Palo Verde Nuclear
Generating Station

**Subject: Palo Verde Nuclear Generating Station (PVNGS)
Unit 1
Docket No. STN 50-528
Response to Request for Additional Information to Proposed
Exigent Amendment to Technical Specification 5.5.9, Steam
Generator Tube Surveillance Program**

**REQUEST FOR ADDITIONAL INFORMATION
PALO VERDE UNIT 1
TECHNICAL SPECIFICATION AMENDMENT - TUBESHEET INSPECTION
(Non-Proprietary Version)**

Figure 2-1

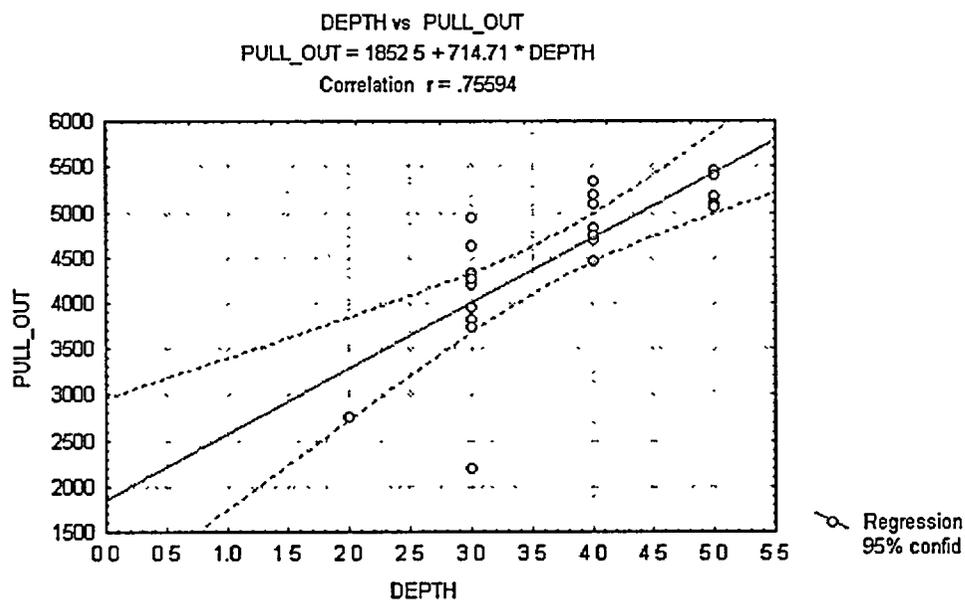
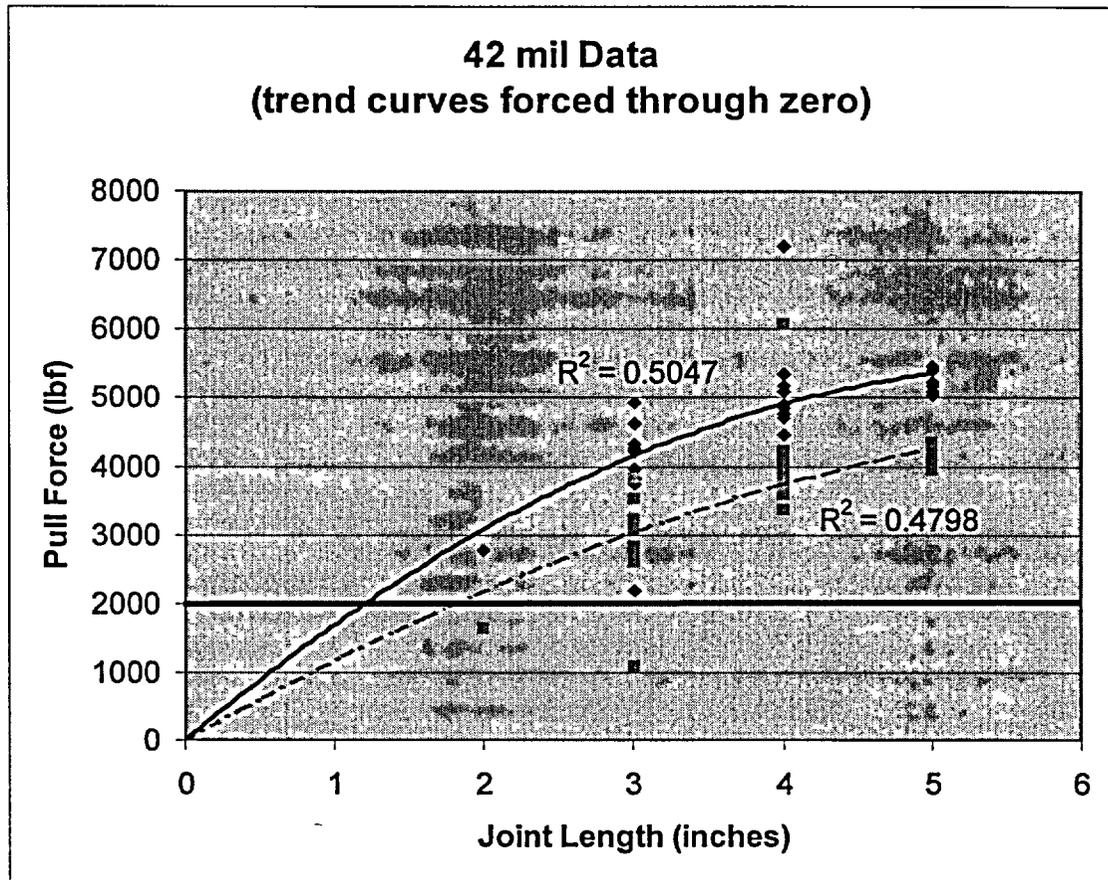
Section 6.0 of WCAP-15947-P indicates that pull test data from two single tube mockup specimens were used in the development of the average pullout load. Discuss the technical basis for assuming the average load rather than a bounding load as well as for not considering the use of the Boston Edison pull test data. Describe the impact the use of a bounding load would have on the tubesheet dilation correction factor. Please discuss the appropriateness of using the coefficient of friction of 0.2. Is this value consistent with (i.e., bound) the experimental results performed in support of the report?

To respond to the NRC Staff's question of what effect the inclusion of all data (applicable to PVNGS) would have on the results, the WCAP 15947-P Sections 4.0, 5.0 and 6.0 information has been re-evaluated to reflect inclusion of all data. As indicated, this re-evaluation did not result in changes to the overall conclusions or basis for the proposed inspection criteria.

With respect to tube pullout, the data (see response to *NRC Question 12*) considered most applicable to PVNGS is the 0.042 inch tube wall thickness data from the BE steam generator and single mockup Specimens 20 and 21. The applicability of this data, with respect to material, design and fabrication variability has been addressed in the PVNGS Supplemental Report and in responses to *NRC Questions 4 and 5*. This data has been plotted in Figures 2-1 and 2-2. It should be noted that the regression fit in Figure 2-1 did not change appreciably from Figure 11 in the PVNGS Supplemental Report. In order to assess the incremental contact force for the flexure analysis, Figure 2-2 provides a polynomial fit to the data anchored at zero. For Figure 2-2 the raw data were also arithmetically adjusted to develop a 95% lower bound fit (e.g., square points).

Figure 2-3

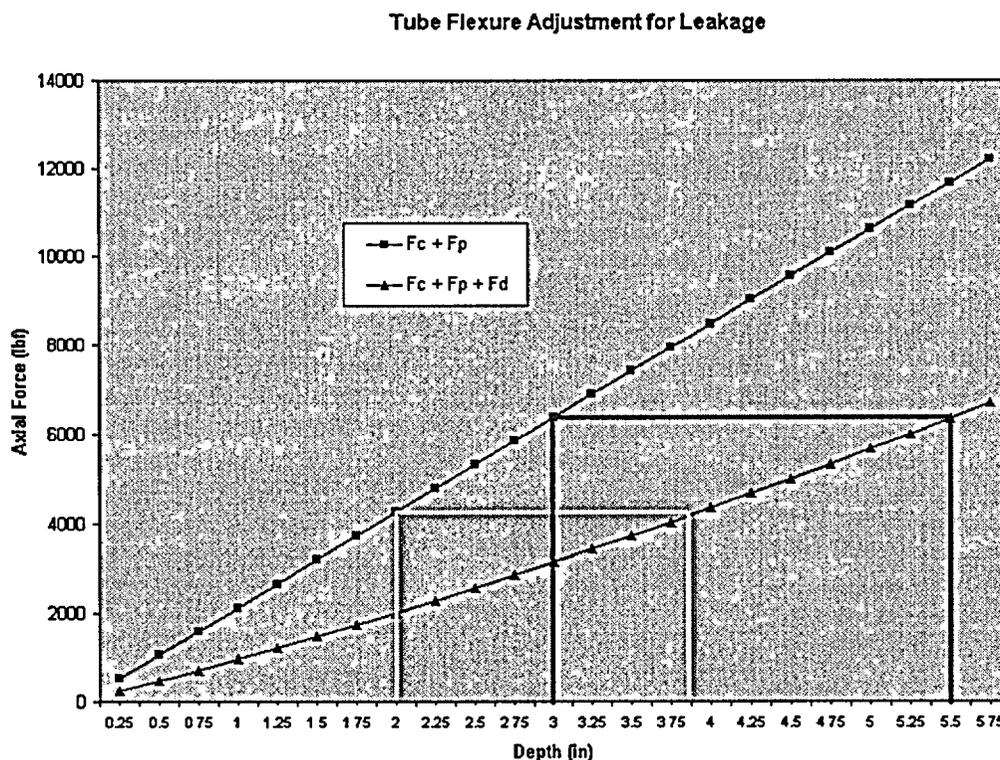
Section 6.0 of WCAP-15947-P discusses the effects of tubesheet flexure on the tube-to-tubesheet contact load. It is stated that tubesheet flexure results in a reduction of the effective contact load with the largest reduction occurring at the top of the tubesheet. Based on an analysis, the licensee concludes that at a set distance below the top of the tubesheet (i.e., the tubesheet dilation correction factor), the resisting load exceeds the bounding pullout load criteria of 2000 lbf determined at 3NODP. The licensee further states that the tubesheet dilation correction factor will provide sufficient resistance to tube pullout to meet the structural integrity requirements. The staff interprets this to mean that the distance associated with the tubesheet dilation correction factor is the minimum distance of non-flawed tubing required to prevent tube pullout. However, Section 8.0 of WCAP-15947-P implies that the distance associated with the tubesheet dilation correction factor must be added to a "tube engagement length" to determine the minimum distance of non-flawed tubing required to prevent tube pullout. Clarify this apparent discrepancy.

As indicated in WCAP 15947-P, the leakage testing on the BE steam generator samples were conducted at ambient conditions to a pressure corresponding with MSLB pressures. In that regard, the test samples were exposed to contact pressures from the expansion and the internal test pressure (F_c and F_p). From Figure 2-3, this sum is plotted per incremental depth. The effect of tube dilation is also plotted ($F_c + F_p + F_d$). The adjustment for tube dilation occurs at the normalization of these conditions such that the cumulative contact force accounting for tube dilation is equivalent to the test conditions. This adjustment for the leakage test results indicates the required engagement length. For the WCAP 15947-P engagement length for leakage (Section 8.2) of two (2) inches, the adjustment would be 1.9 inches. As indicated in APS response to *NRC Question 19*, APS has elected to use an engagement length of three (3) inches to bound the test data. The corresponding adjustment to the APS specified engagement length for leakage for tubesheet flexure as shown in Figure 2-3 as 2.5 inches. The value is listed in Table 1 of the RAI *Introduction*.

In summary, the results presented in Table 2-2 are expected in comparison to W^* . The CE joint is designed to have residual contact force at ambient conditions, and is considered more representative of a rolled joint in terms of contact pressure, and is therefore conservative to the W^* application. The test and analysis results indicate that a 2.25 inch adjustment over and above to the required engagement length for pullout provides significant conservatism. The adjustment for leakage permits a connection between the analyzed effect for tubesheet flexure and the leakage test program. This adjustment, along with test data that indicates that additional compression can be expected due to thermal expansion (not considered in Table 2-2), is also conservative. Both adjustments for tubesheet flexure in relation to the total proposed inspection length are given in Table 1 of RAI *Introduction*.

Figure 3-1 WEXTEx Joint

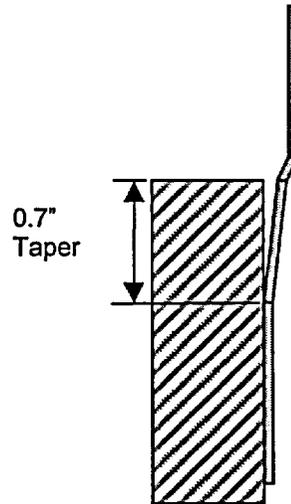
The Supplemental Report to WCAP-15947-P indicates that beginning in the Fall 2002 refueling outage (U1R10), the licensee will record the bottom of expansion transition (BET) location for all tubes. In addition, the supplemental reports states that if the BET location is greater than 0.7 inches below the top of the tubesheet then the inspection extent (i.e., 7 inches) would need to be increased accordingly. Please clarify if the BET location will account for effects due to both underexpansion of the expansion joint as well as taper of the joint. In addition, discuss whether you plan to modify the 0.7 inch value based on results from the ongoing steam generator tube inspections at Unit 1. Lastly, the commitment to increase the inspection extent under these circumstances must be incorporated into your Technical Specifications.

Both WCAP 15947-P and the PVNGS Supplemental Report make comparative statements with respect to the WEXTEX joint which contains a non-contact region defined as a taper (see Figure 3-1).

As indicated in WCAP 15947-P, microscopic examination of tubes and tubesheet single tube mockups removed after pullout testing indicate that a similar taper is essentially non-existent in a CE expansion joint. WCAP 15947-P further states that the lack of a taper in CE-designed joint is reasonable to expect because of the process design and controls. The expansion charge assembly illustrated on Figure 1.2 of WCAP 15947-P shows the plastic charge carrier extending beyond the secondary face of the tubesheet. The carrier served two purposes: (1) to hold the position of the primer cord and (2) to carry the explosive force uniformly through the range of the tubesheet. The explosive force combined with the carrier function apparently is effective in providing a distinct transition from expanded to unexpanded tube diameter and negating any reduction in contact at or just below the bottom of the transition (i.e. taper).

Unit 1 Tube (Noise ~ to Unit 1 Mean)

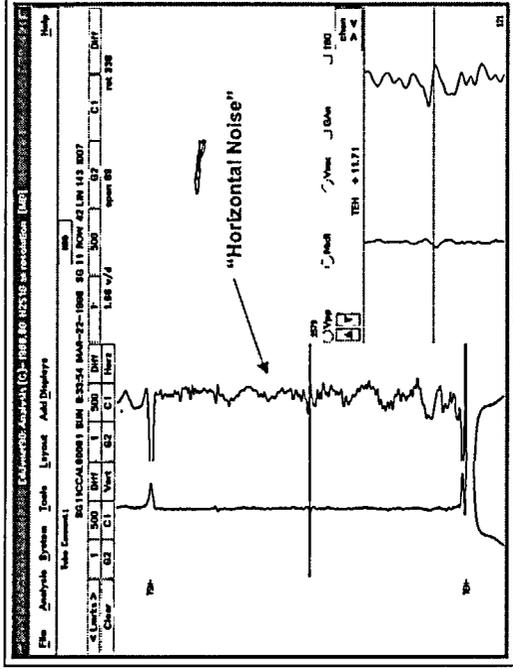
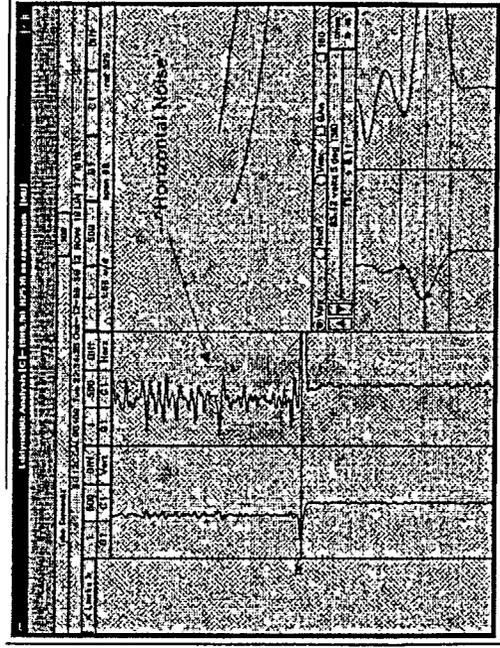
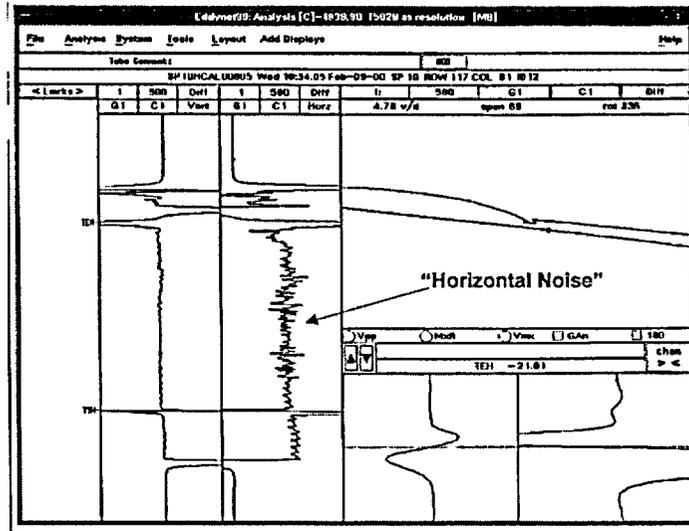
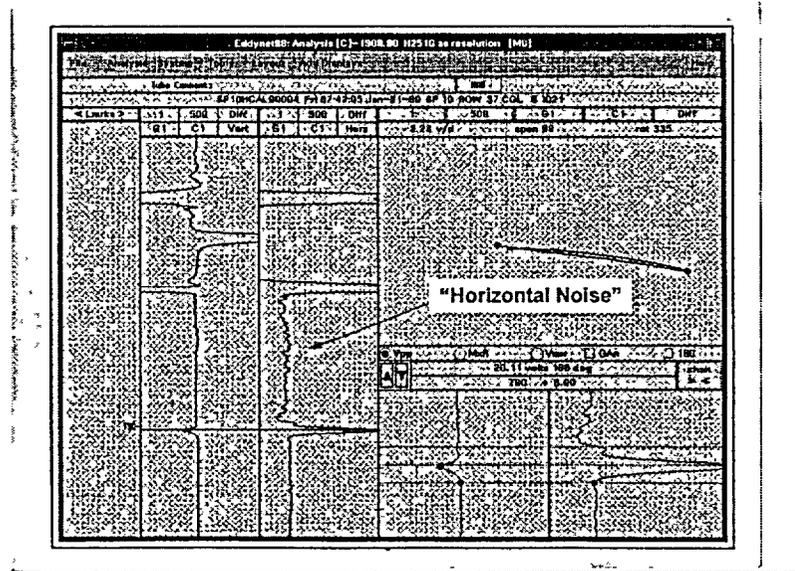
The Supplemental Report to WCAP-15947-P describes a noise evaluation that was performed to confirm that Unit 1 bore roughness was consistent with a rough bore characterization. The report concludes that the Unit 1 joints are comparable to the Boston Edison joints. Please clarify what factors or conditions were determined to be comparable.

The noise evaluation performed by APS was conducted as a point of reference. As indicated in Section 1.2 of WCAP 15947-P, a gun drill process was used for drilling the PVNGS Unit 1 steam generator tubesheets. In the original CEOG study, it was reported that Combustion Engineering changed their drilling process during fabrication of the PVNGS Unit 2 steam generators. The new process referred to as a Bore Trepanning Process (BTA) was adopted to increase productivity. The process had a consequential effect of producing smoother bore surfaces. For this reason, steam generators were either classified as rough bore or smooth bore in the CEOG study. Although CE was knowledgeable regarding the time frame the switch was made to BTA, fabrication records did not explicitly call out whether the tubesheet holes were gun drilled or drilled using BTA. However, time line records showed that both Unit 1 steam generators and the Boston Edison steam generators were fabricated prior to the change to BTA.

In evaluating all six PVNGS steam generators, APS found that a distinct difference in the ECT horizontal noise signature between Unit 1 and Units 2/3. The results appear to confirm CE fabrication records indicating a change to the BTA process sometime during fabrication of the Unit 2 steam generators. APS requested similar ECT measurements of the BE steam generator and a visual comparison of the graphics indicates a similarity in horizontal noise. The BE raw data was not subjected to the same newly developed noise software, and therefore this data was not quantitatively addressed in the APS noise study. However, example graphics of a BE tube, Unit 1 tubes (including a mean level noise) and a smooth bore mock-up are provided below. These graphics are all measured at the same span for comparative purposes.

Based on this evaluation and CE records, APS concluded that the fabrication process used in the Boston Edison (BE) steam generators was the same as PVNGS Unit 1. As such, the results could be used without adjustment.

Figure 9-1

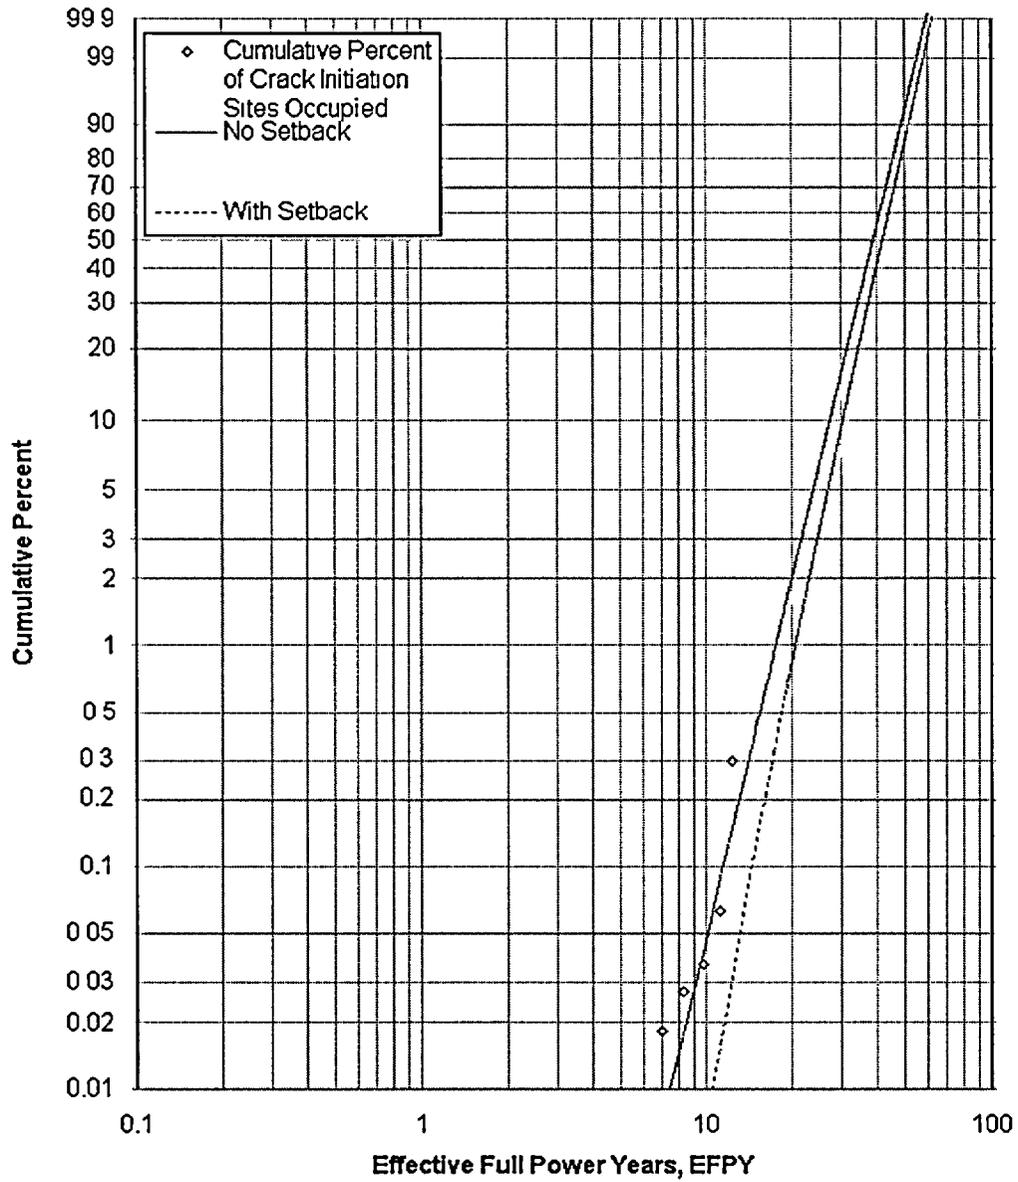
In the Supplemental Report to WCAP-15947-P, the licensee concludes that the projected number of undetected flaws in the region of the tube inspected only with the bobbin coil, at 95% probability, is significantly less than the 1100 tube assumption used in the CEOG report. Given that the licensee's projection is a current projection, and the license amendment is requested as a permanent amendment, what assurances are there that the 1100 tube assumption used in the CEOG report will remain conservative as the SG tubing in the lower region of the tubesheet continues to degrade? Why shouldn't all tubes be assumed to have the potential to leak?

The staff recommends you consider performing an analysis that predicts the number of undetected circumferential flaws that will be present when the Palo Verde Unit 1 license expires. This analysis should be benchmarked based on the current inspection results, as well as at every refueling outage, by comparing the total number of circumferential cracks detected against the predicted number of undetected circumferential cracks at the mean

The analysis (Figure 9-1) indicates that the number of predicted tubes will be below the 1100 tube assumption until 31 EFPY. Based on the current licensed life¹, the expected end of life EFPY is 30-32 EFPY based on the current EFPY (12.4) with an 80-90% capacity factor. It should be noted that the expected capacity factor for Unit 1 should the existing steam generators last until end of life should be less than this assumption, based on plugging projections and maintenance issues associated with Alloy 600 MA steam generator tubing.

As such, the 1100 tube assumption in WCAP 15947-P is considered reasonable for an end of life prediction for Unit 1.

Figure 18-1

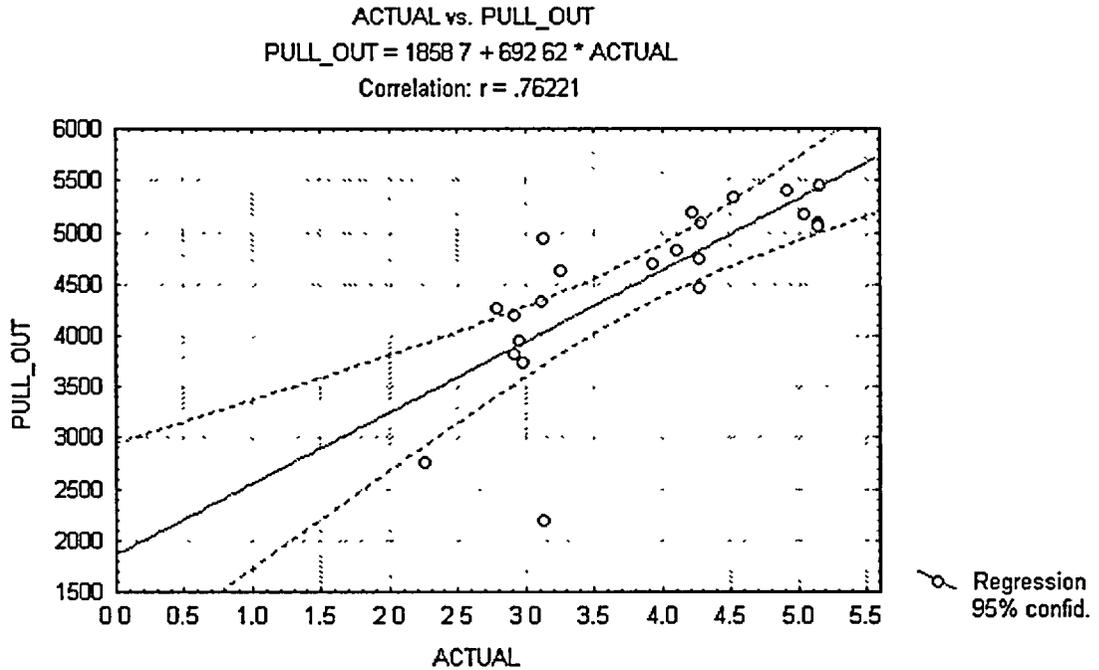
The tables in Sections 4.0 and 5.0 of WCAP-15947-P list Target Length and/or Actual Length. Explain what the Actual Length signifies. Why are actual lengths not provided for all data points? The Actual Length for Specimen number 21, which had an unexpectedly low pull out force, is not provided. Provide the Actual Length for this specimen, if possible, as it is the data point driving the 3.0 inch joint length depicted in Figure 11 of the Supplemental Report to WCAP-15947-P. It would be particularly in helping the staff understand whether the recorded pull out force for Specimen 21 is conservative or non-conservative.

A review of the test records indicates that actual lengths are available for Specimens 20 and 21. These are provided in Table 12-1 of APS response to *NRC Question 12*. A few actual lengths of the BE steam generator samples were located and entered in Table 12-1 as well. Also, the third column in WCAP 15947-P, Appendix B, entitled *Position (in) @ Force = 0* is the distance the tube was pulled before the load cell reading decreased to essentially zero. This should be a number close to the actual joint length, limited by the accuracy of the MDM head positioning and the data acquisition rate. APS evaluated these results with for a comparison with Figure 2-1 of APS Response to *NRC Question 2*. The results (Figure 18-1) indicate little change in the regression fit. The correlation improves somewhat, and the results continue to support the conclusions of WCAP 15947-P and indicate that the minimum engagement length of three (3) inches conservatively bounds the 95% confidence fit. Although, the actual length of Specimen 21 failed to provide any additional insight as to why the pullout load deviated significantly from the other data, APS believes that the discussion provided in APS responses to *NRC Questions 4, 5, and 12*, provide substantial evidence that the CEOG test data from the BE steam generator is the most applicable to PVNGS Unit 1. However, APS elected to include the results from all testing, including Specimen 21 in specifying minimum engagement length
